**RE: 3726 Camp Letts Road, Edgewater MD, 21037
Variance Application – Explanatory Letter**

Point-by-Point Response to Comments Generated from Pre-File:

VARIANCE PLAN 3726 CAMP LETTS RD

OFFICE OF PLANNING AND ZONING
CONFIRMATION OF PRE-FILE

EXISTING DRAINAGE AREA TO SITE OUTFALL

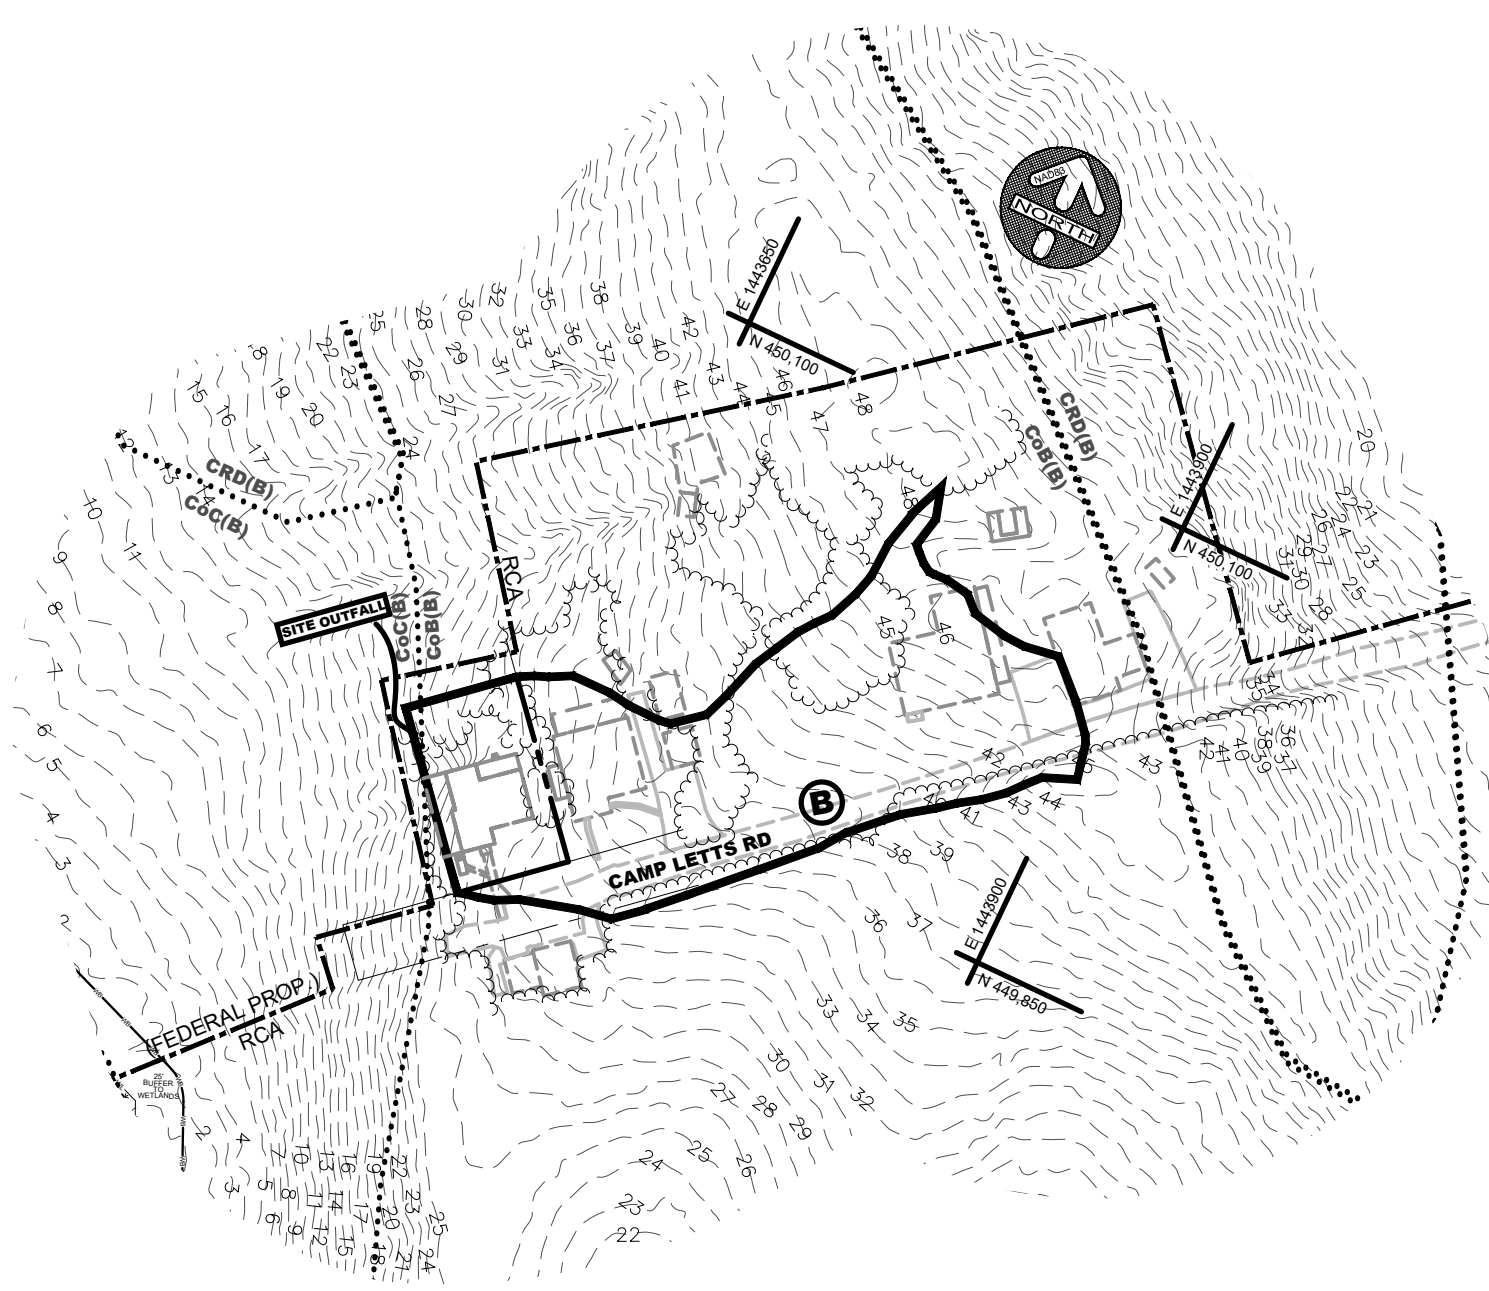
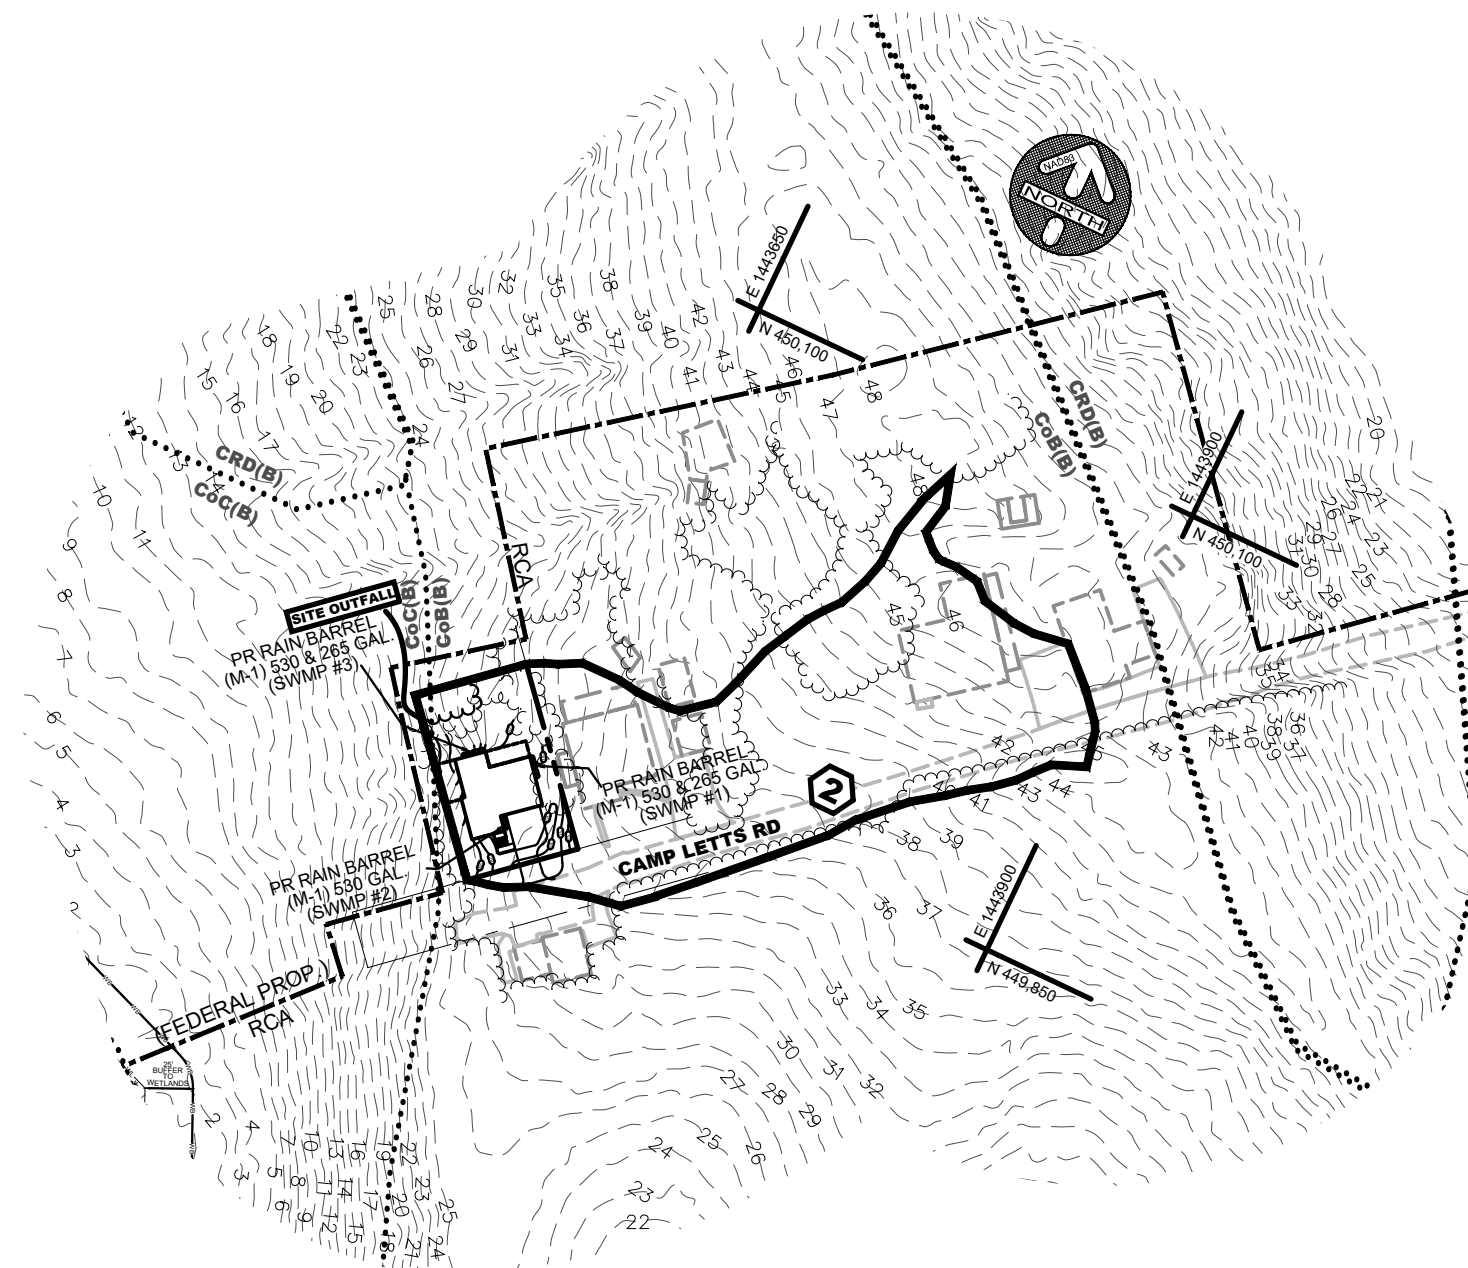
Comment 2: Identify site outfall to review the site plan and provide feedback regarding potential impact.

Response: The site outfall and outfall statement are both shown on the grading plans and have been reviewed by the engineering department.

PROPOSED ESD SUB-DRAINAGE AREAS

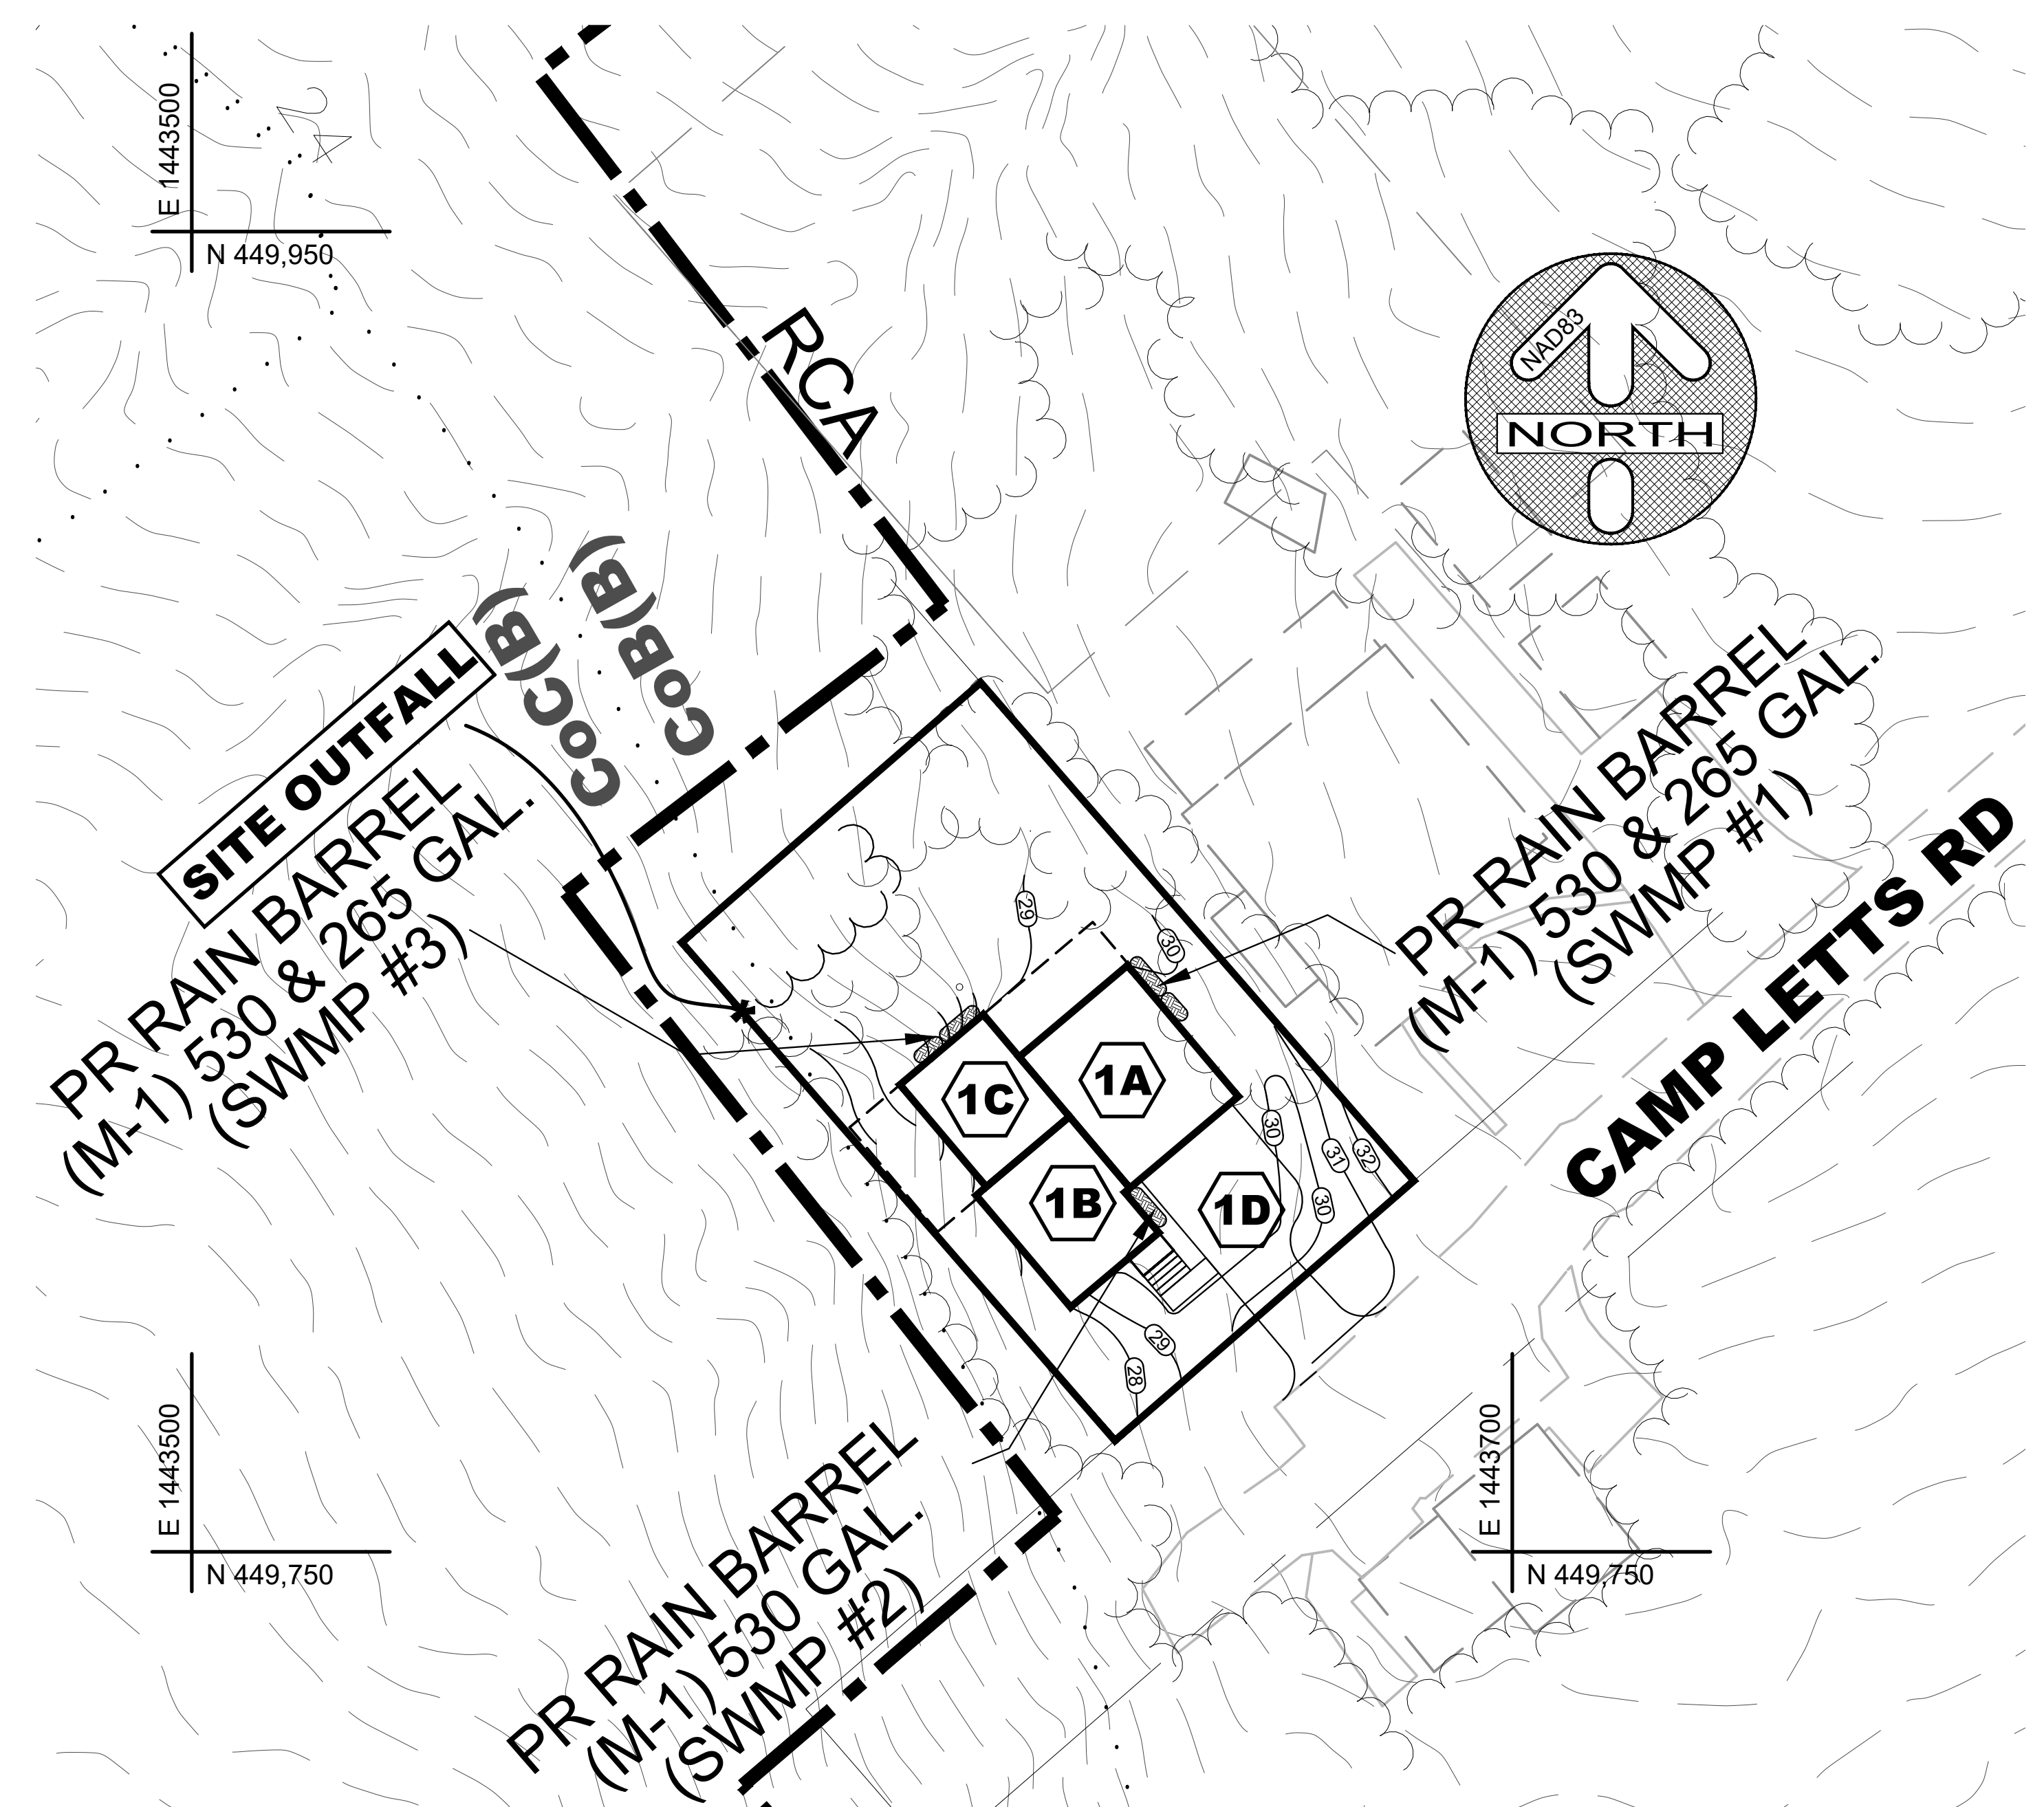
Comment 1: There are three Rain Barrels proposed for this project. How is the water reused and show the area of the dedicated use? For example, if the water is used for irrigation purposes, need to call out the area on the plan and it should be a dedicated use. The water shall not cause downstream flooding or nuisance flooding to neighboring properties, please show and label.

Response: The water will be used for irrigation purposes and this comment was addressed with the grading permit by showing an irrigation area and having notes about using the water to water the lawn and or plants.

The SWM will reduce the runoff leaving the site from existing conditions to proposed conditions, therefore the development will not cause downstream flooding or nuisance flooding to neighboring properties, this is better spelled out in the SWM report, within the outfall statement, and showing the reduction on the QP10 computations.
